Project: **TOUCHSTONE VILLAGE CENTER**  
 for: **CROSLAND GROUP**  
 Sheet Title: **REZONING PLAN**

SUBJECT: Administrative Approval for Petition #90-13  
 Tax Parcel #223-025-02

SUBJECT: Administrative Approval for Petition No. 90-13 by Touchstone Assoc. Ltd. Partnership Tax  
Parcel # 223-025-02

SUBJECT: Administrative Approval for Petition No. 90-13 by Touchstone Associates Ltd. Partnership  
Tax Parcel # 223-025-02

REVISIONS	Project	Drawing	
No.	Date	Charlotte, NC	Exterior Elevations
1	8/2/95	Owner	DAVIS CONSTRUCTION COMPANY, INC
		Scale	2208 W. Roosevelt Blvd., Monroe, N.C. 28110
		Date	Sheet No.
		Drafter	A-3
		Acad.	
		Check

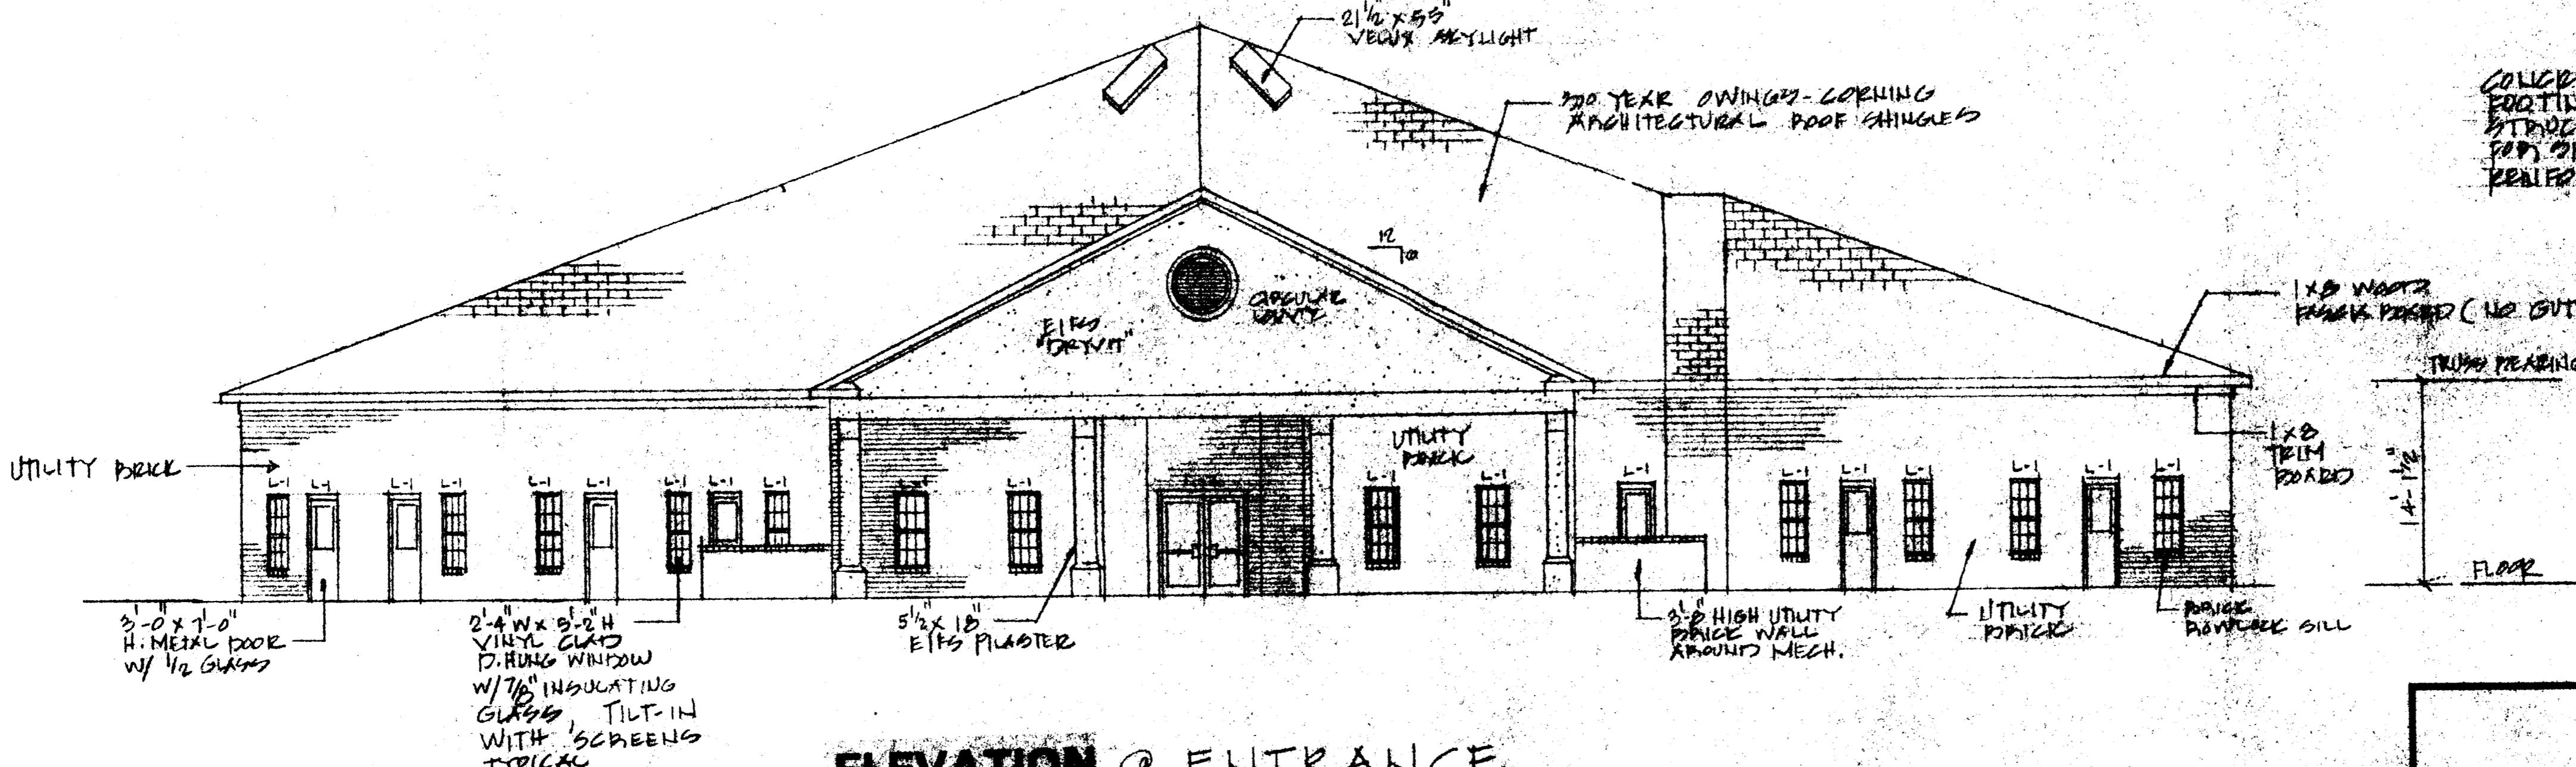
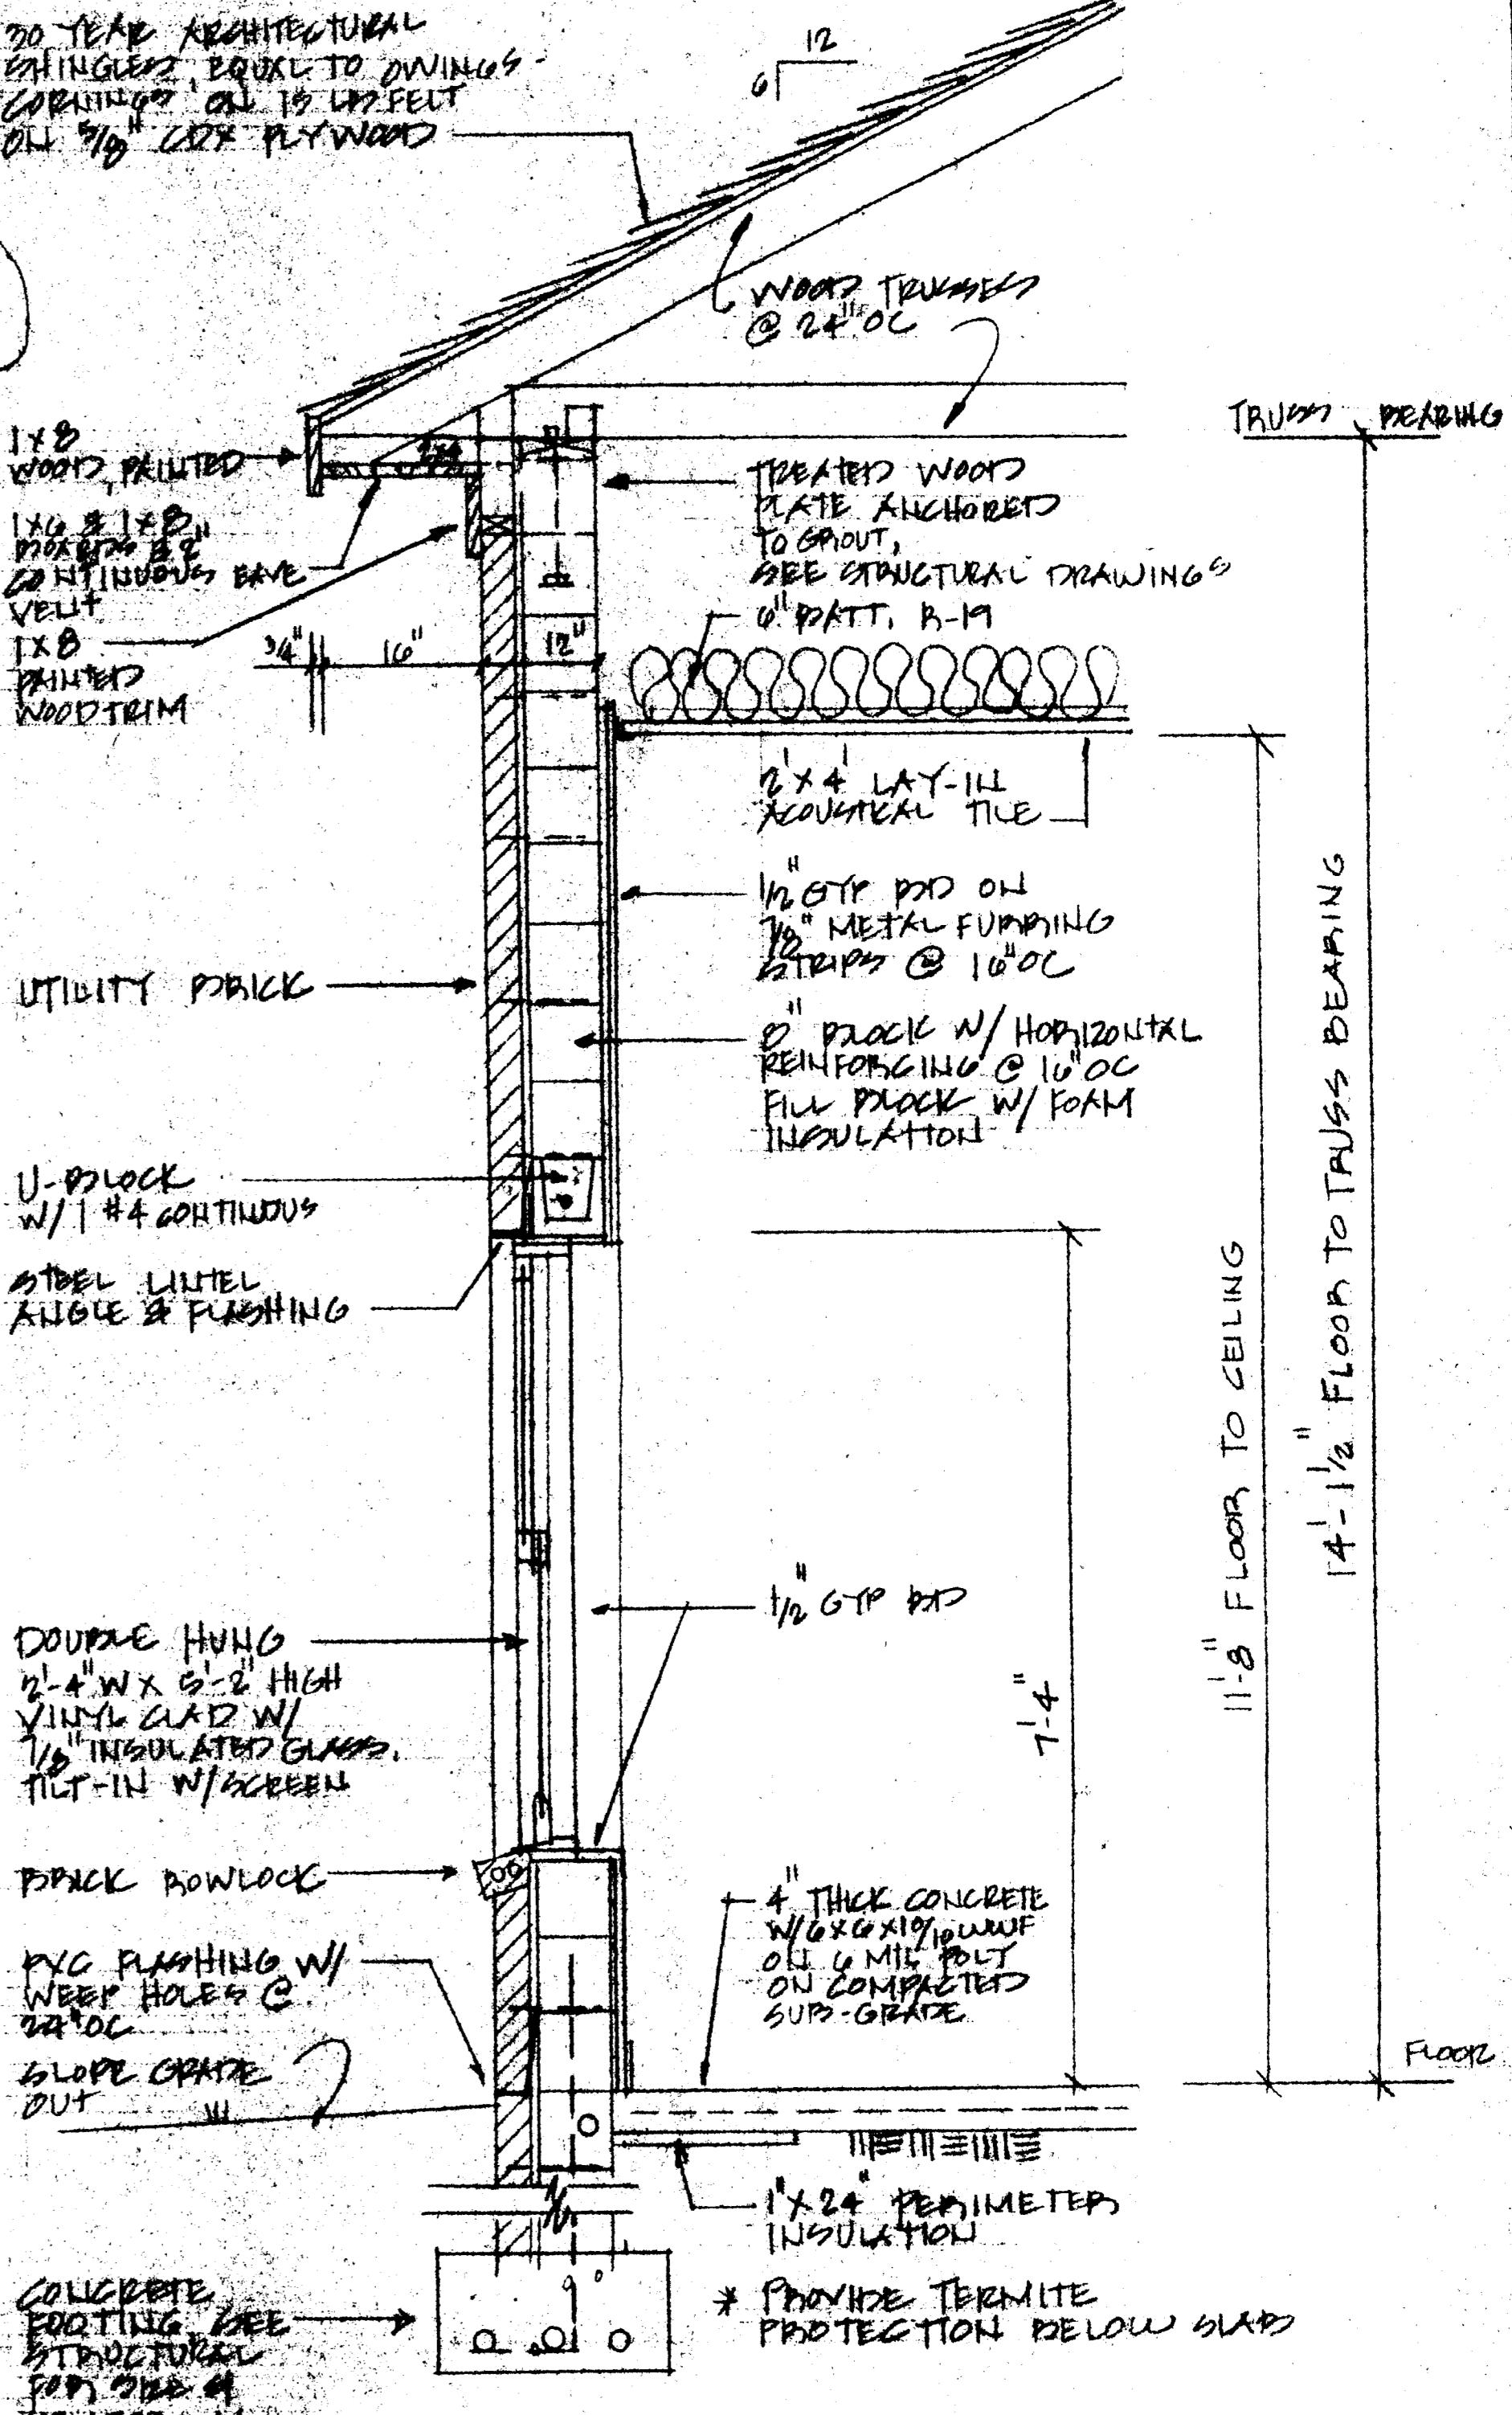
Also included are building elevations noting that the building will use the same brick and roofing material as the shopping center.

THE EXTERIOR BRICK & ROOF MATERIALS NEED TO BE THE SAME AS THE ADJACENT SHOPPING CENTER
